January 30, 2025

Memo To: Giuseppe Russo, Planner II
Memo From: James Pavlidis, Urban Designer

Subject: Official Plan and Zoning By-law Amendment Applications
Applicant Name: KLM Planning Partners Inc.
Municipal Address: 0 Longworth Avenue (12460 Leslie Street)
City File No.: OPA-24-0003, ZBLA-24-0005

Annotated Site Plan: Reconfigure the siting and massing of Building 'B' to frame the Leslie Street frontage, continue the pedestrian streetwall, achieve appropriate massing, scale, transition and interface with the adjacent low-rise residential context to the south.

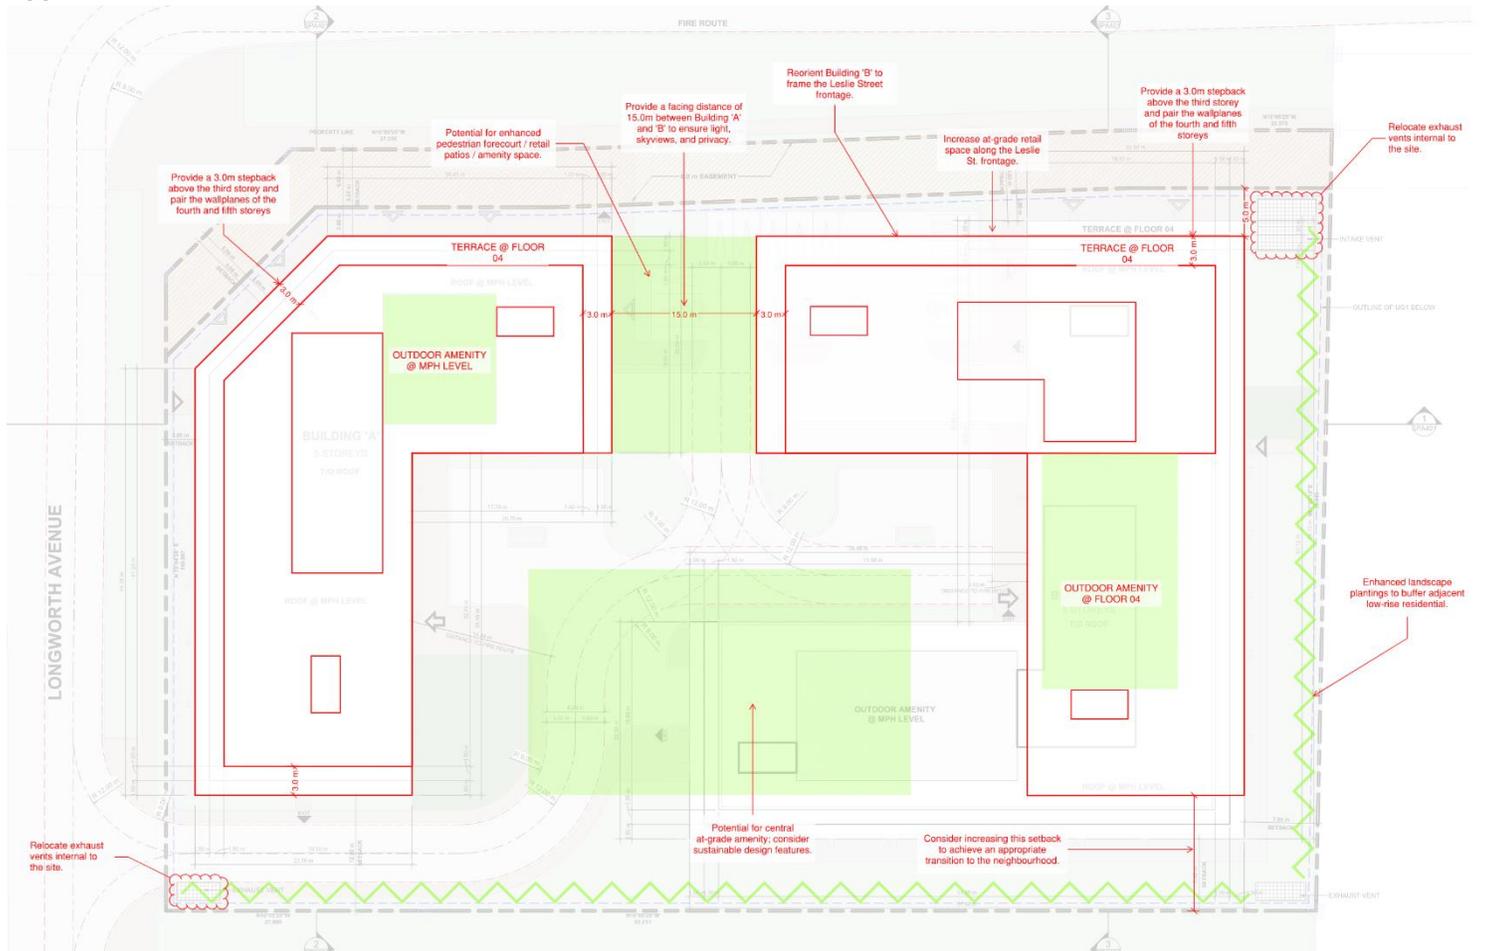
B) Site Organization		
Issue	HUD Staff Comments	Reference
1. Building 'B' Configuration	<p>Street and building relationships play an important role in establishing a human scale and connection to the public realm. Moreover, corner sites should be designed to address both public frontages through the siting, massing, and enhanced articulation of buildings.</p> <p>Staff have observed that Building 'A' has been sited to frame the public realm along both Leslie Street and Longworth Avenue, appropriately addressing the corner; whereas Building 'B' has been sited at the southwest corner of the site, with much of the massing interfacing along the west and south lot lines. Only a small portion of Building 'B' frames the public realm.</p> <p>To further address and articulate a legible pedestrian streetwall along the Leslie Street frontage, the applicant should reorient the massing of Building 'B' towards the public street, aligning the east elevation with that of Building 'A', and directing the tallest volume away from the low-rise residential context, gently transitioning down in scale. Refer to the annotated Site Plan, appended below.</p>	OP 3.4.1.30, 3.4.1.31, UDGs 5.2.1, 5.2.3, 6.2.1, 6.5.1, 6.5.17

Annotated Building 'A' South Elevation: To decrease the overall height and achieve an appropriate scale, lower the ground floor heights of buildings from 7m to 5m; maintain the minimum required vertical clearance for waste collection vehicles.

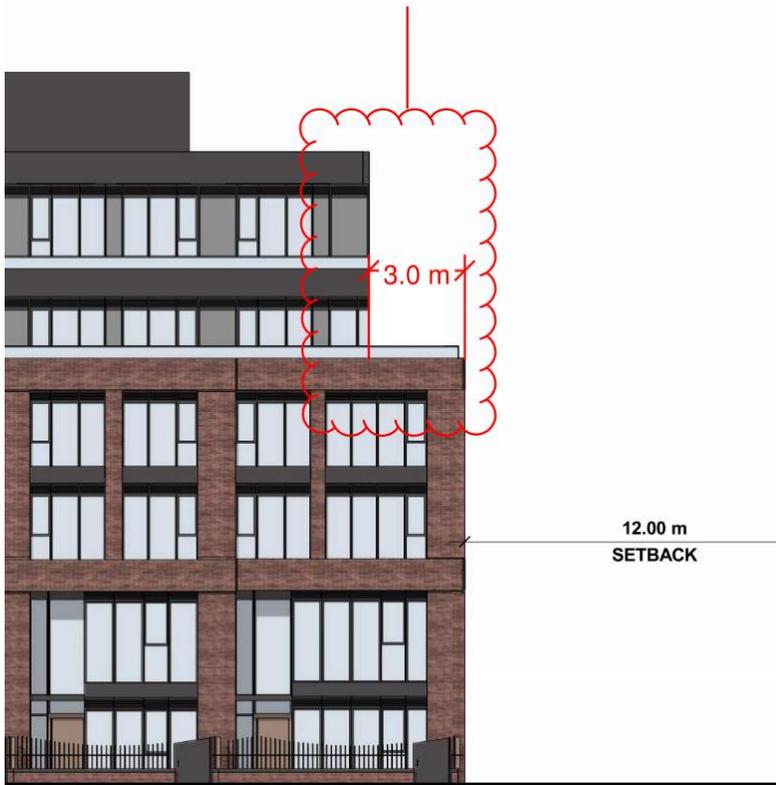
Issue	HUD Staff Comments	Reference
2. Ground Floor Height	<p>to appropriately transition in height and scale, and positively interface with the low-rise residential dwellings immediately adjacent.</p> <p>Further to the above, the SPA301-304 Elevation drawings indicate that the ground floor height of Building 'A' and 'B' is 7.0m. Staff note that to accommodate retail commercial uses, ground floor height should be 4.5m. Given the surrounding planned and emerging low-rise residential context, the applicant should reduce the height of the ground floor to no more than 5.0m, to decrease the overall height of the buildings and achieve an appropriate scale. See annotated Building 'A' South Elevation, appended below.</p>	UDG 3.5.1, 6.5.5, 6.2.6, DGRU 2.1.1
